PLANNING AND ZONING COMMISSION SITE PLAN SUBCOMMITTEE

March 7, 2016- Monday

Re: P.Z. 21, 22, and 23-14 Stone Mill Subdivision, Lombardo Homes of St. Louis, L.L.C.

P.Z. 25, 26, and 26a-14 Main Street Crossing, Payne Family Homes L.L.C.

2.0

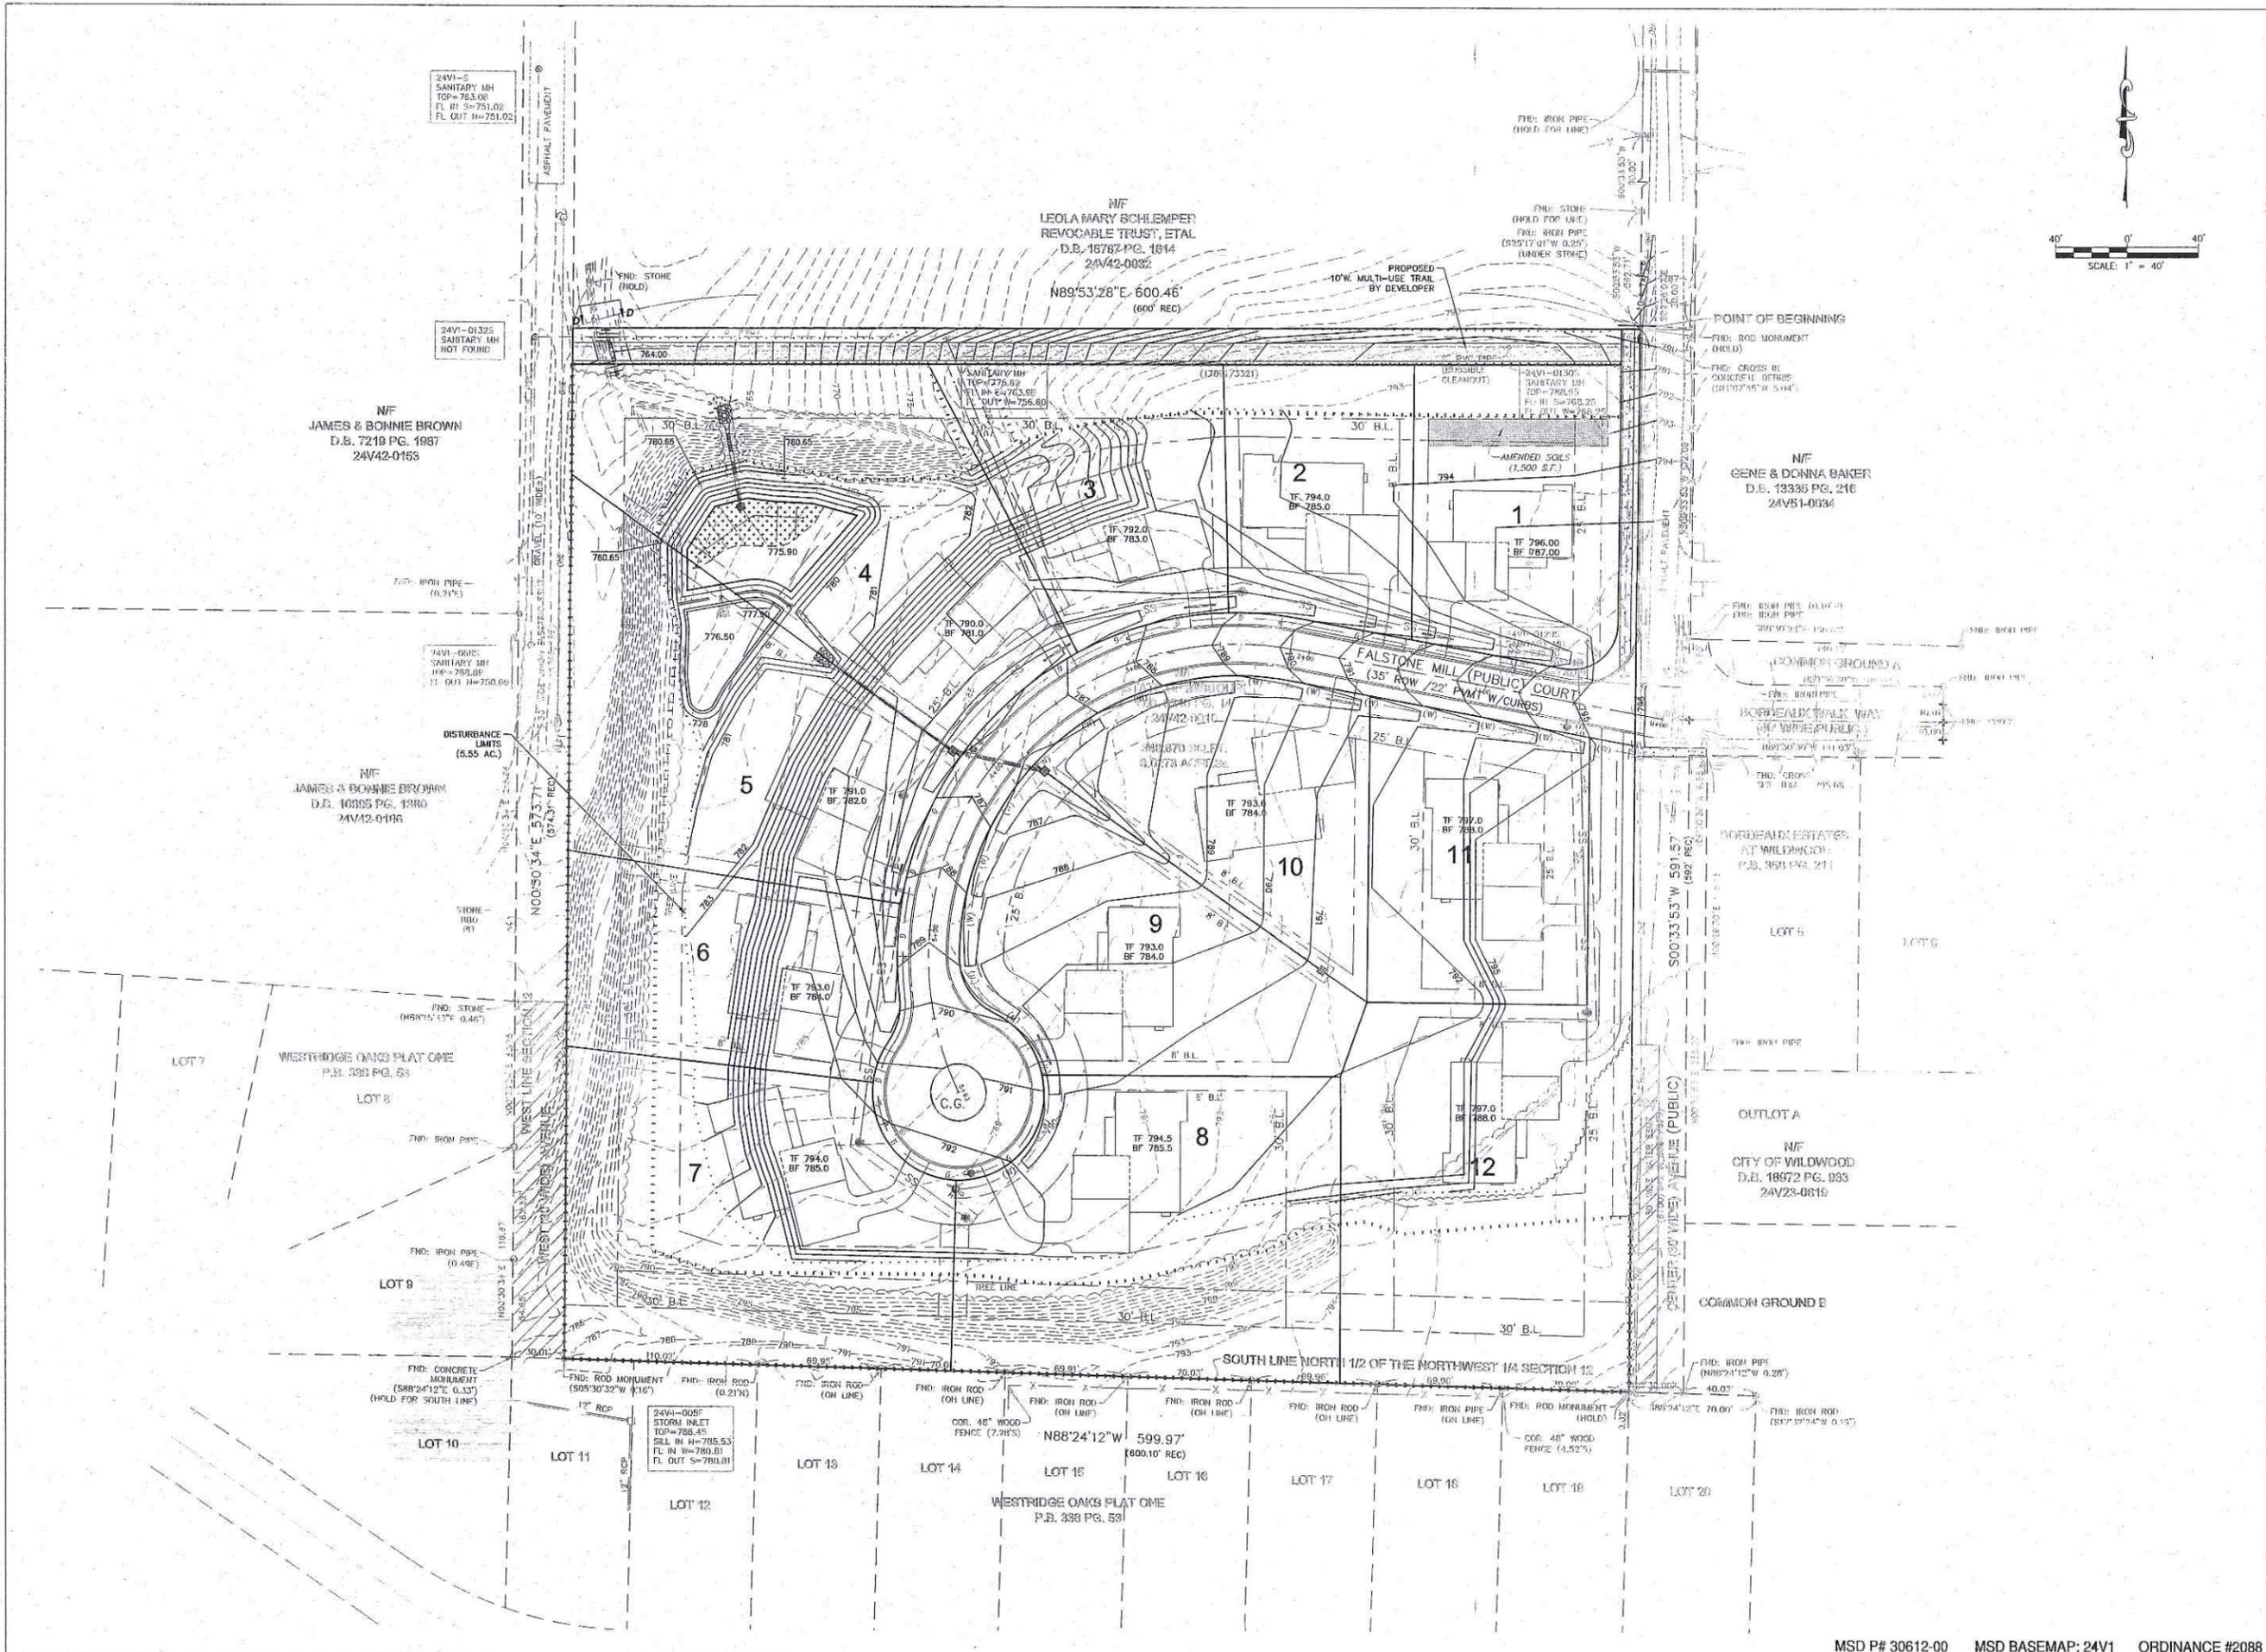
12. Please add "(by developer)" to the note indicating the proposed ten foot (10') multi-use trail on Sheet 2.
13. Please remove any easement to MSD that is located within the fifty foot (50') non-disturbed buffer area and the Natural Resource Protection Line.

9. Provide the zoning of adjacent parcels of ground, if different than the site.
10. Please add the public space table to Sheet 2.0, given the trail constitutes much of the dedication.

Main Street Crossing
 2461 EATHERTON RD., WILWOOD, MO
 SDP - SITE PLAN

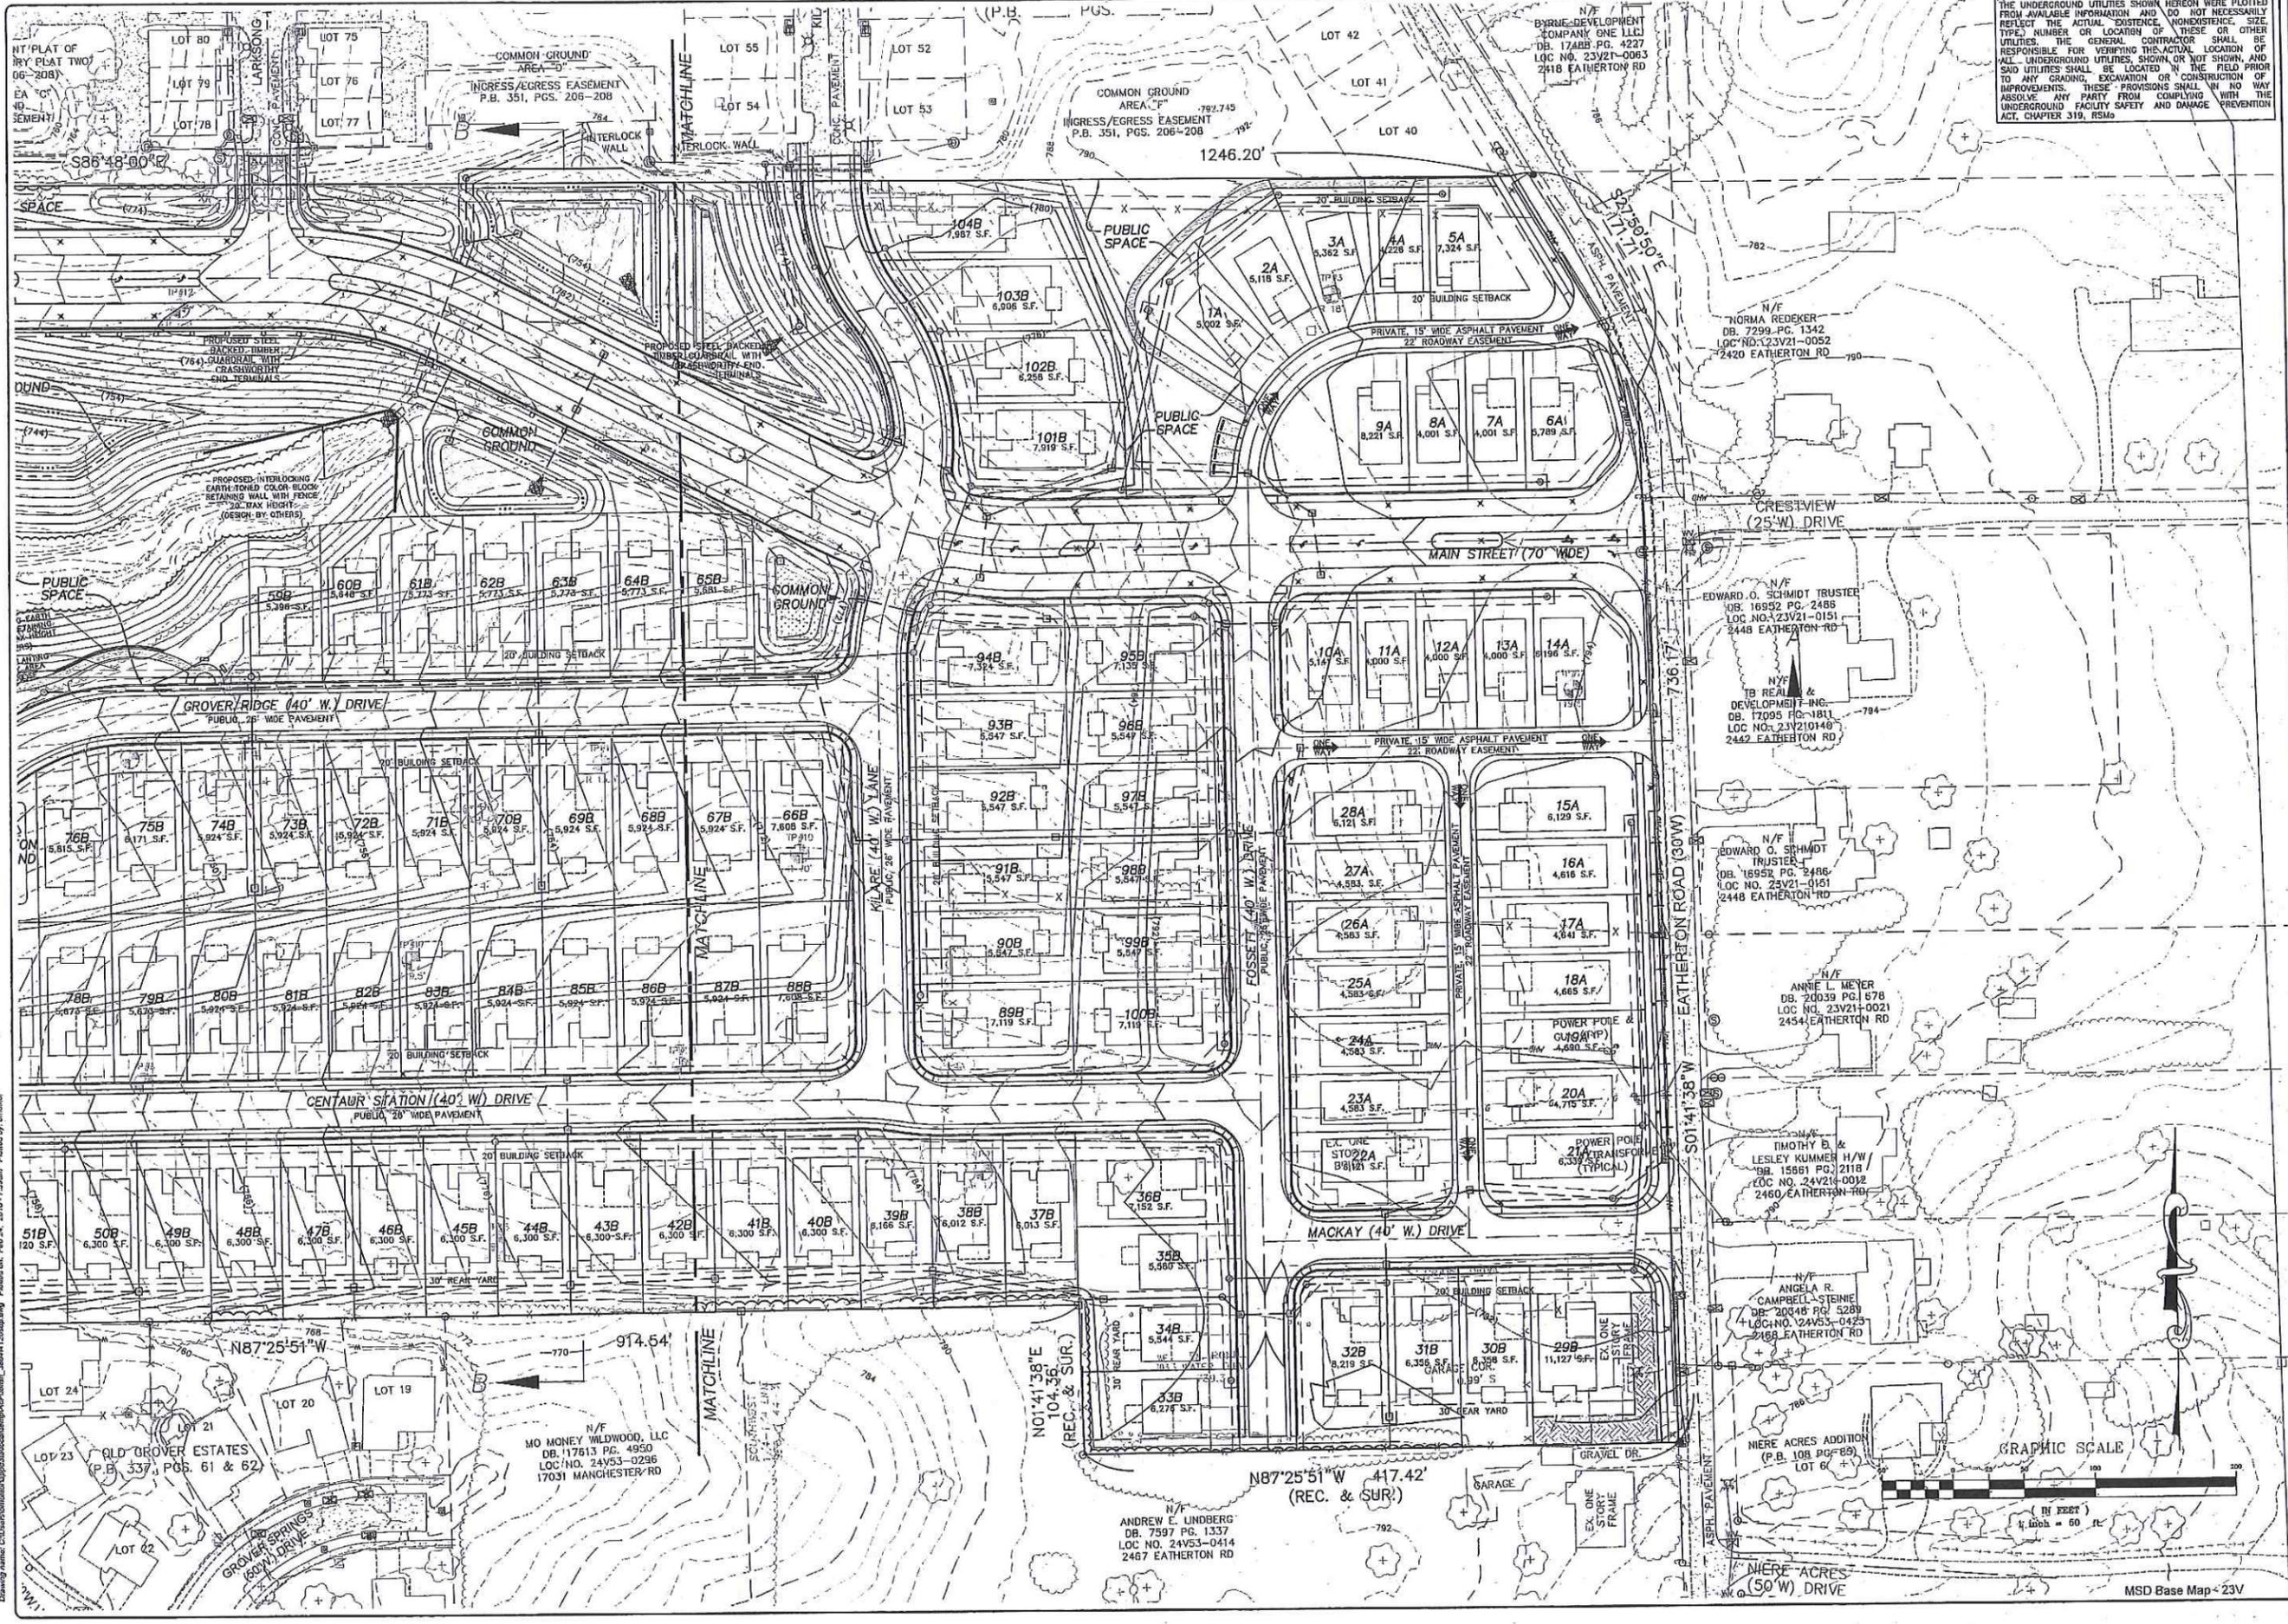
11. Please identify all proposed retaining walls by height and materials, along with the color of blocks. (Correct on Sheet 2.2 also)
 12. Please identify the guard rail as a wood-backed type that has been used by the City along its trail system on State Route 100 and include crashworthy end terminals as well. (Correct on Sheet 2.2 also)
